BASIC Stamp[®] 2sx Change Notice (for Interpreter Chip Users)

This document contains details of revisions made to the BASIC Stamp 2sx interpreter chip firmware as well as the BASIC Stamp 2sx module. This information is intended only for use by customers who purchase the BS2sx interpreter chips and embed the BASIC Stamp 2sx circuit into their designs.

BASIC Stamp® BS2sx-IC Module Schematic Rev. F

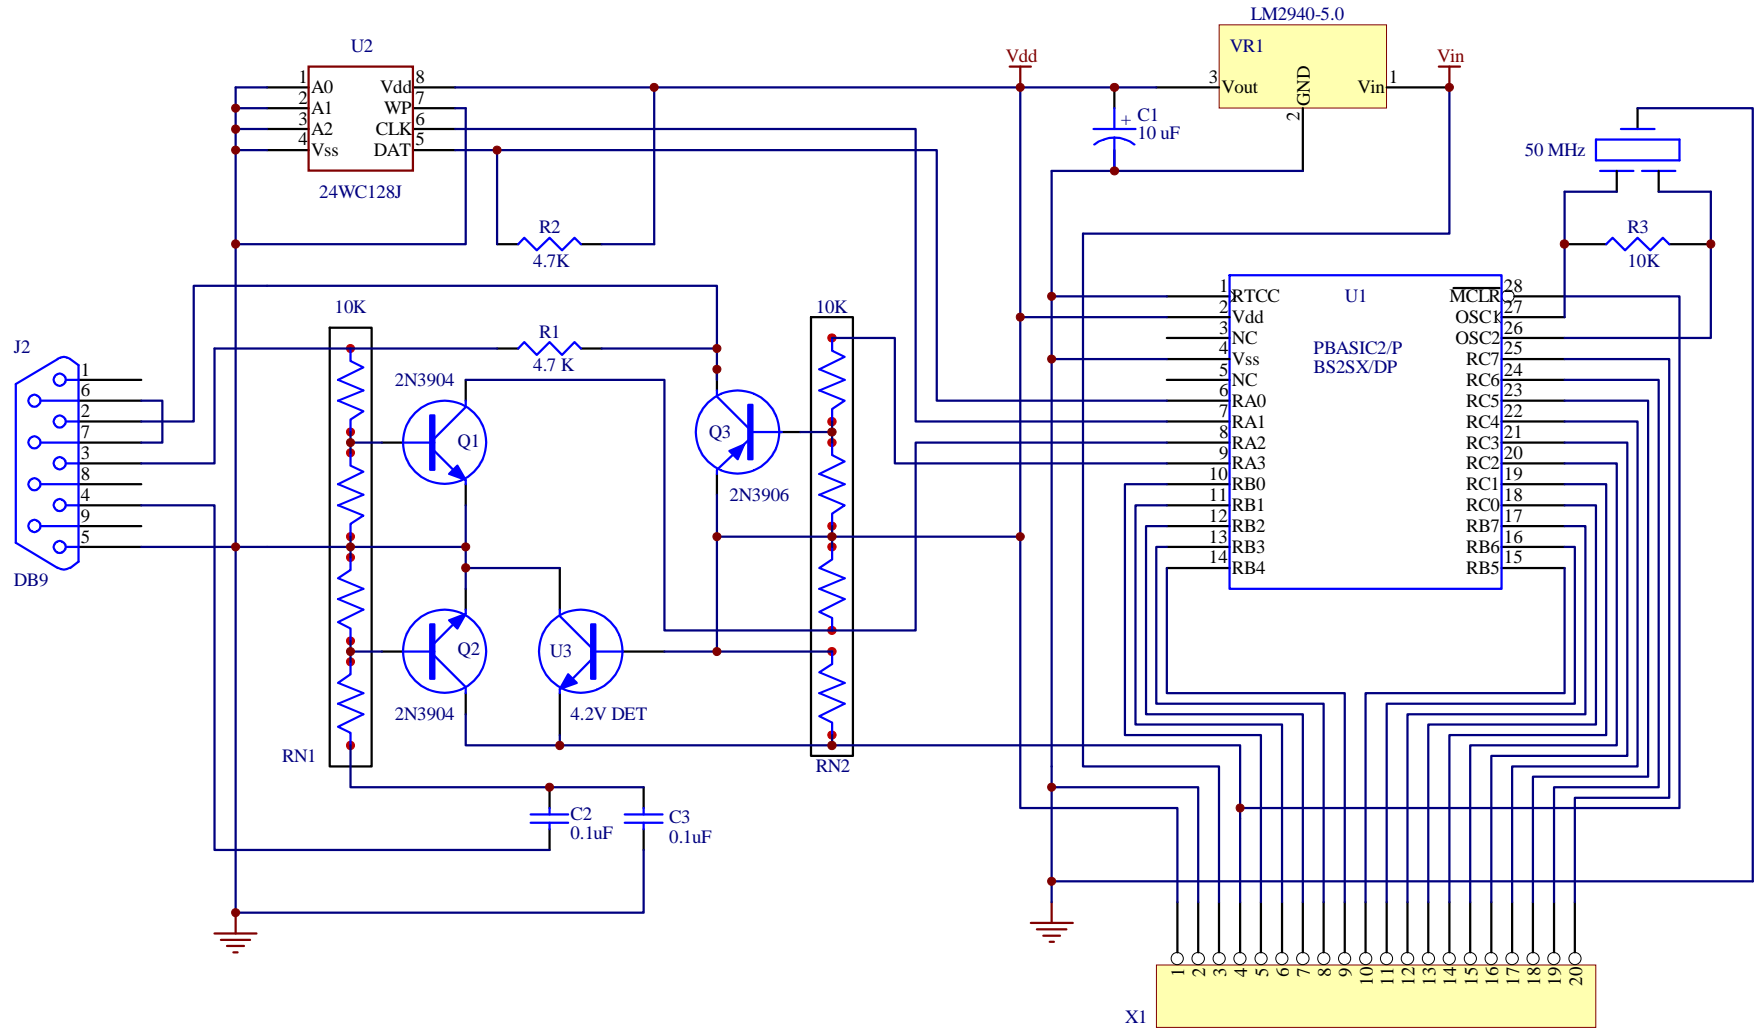
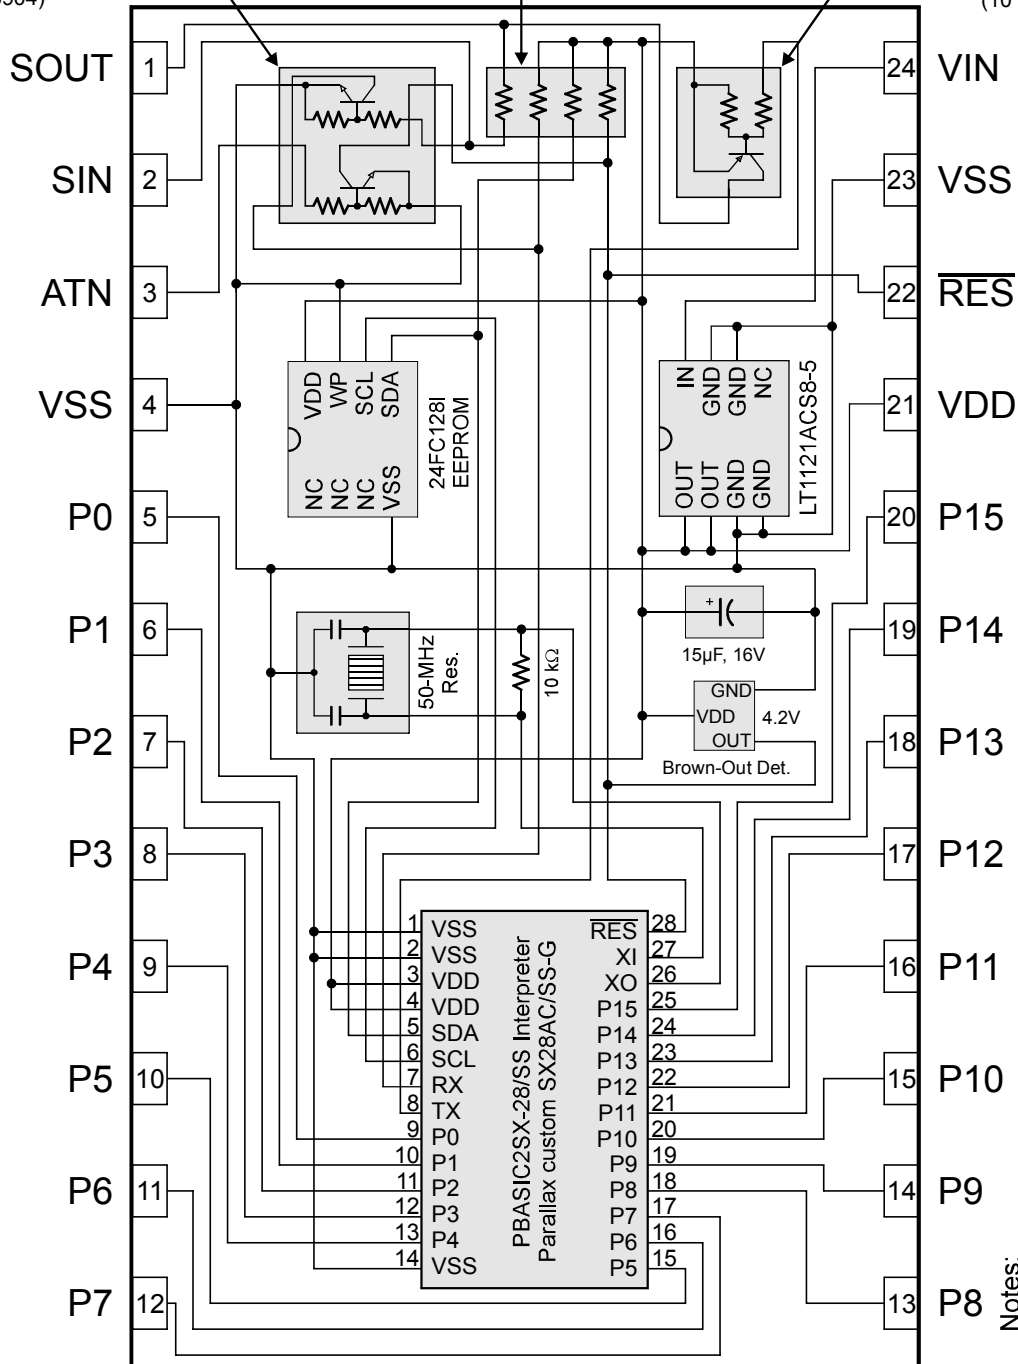
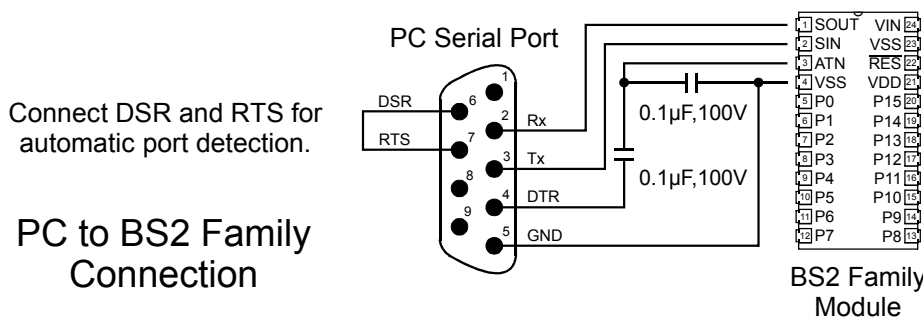
Interpreter chip firmware updated to v1.3.

- Disabled internal interpreter brown-out detector. This change requires that, instead, an external brown-out detector be included in the circuit for proper operation.
- BASIC Stamp Editor v2.3.1 (or above) supports this new firmware version.

EEPROM changed to a Microchip 24FC128I. The previous EEPROM (Catalyst 24WC128J) has been discontinued by the manufacturer. This change is independent of the firmware update; if you have a supply of EEPROMS that you've successfully used in previous builds, there is no need to change it. NOTICE: The Catalyst 24C128WI is not recommended for use in the BS2sx circuit.

The 50 MHz resonator has been replaced with a RoHS compliant, industrial, resonator.

- A 10 K Ohm feedback resistor across the XI/XO pins of the resonator is used to optimize oscillation across the industrial temperature range.

The schematic on the following page shows the current design in use, as described above. Please review it to aid in adjusting your BS2sx embedded designs.
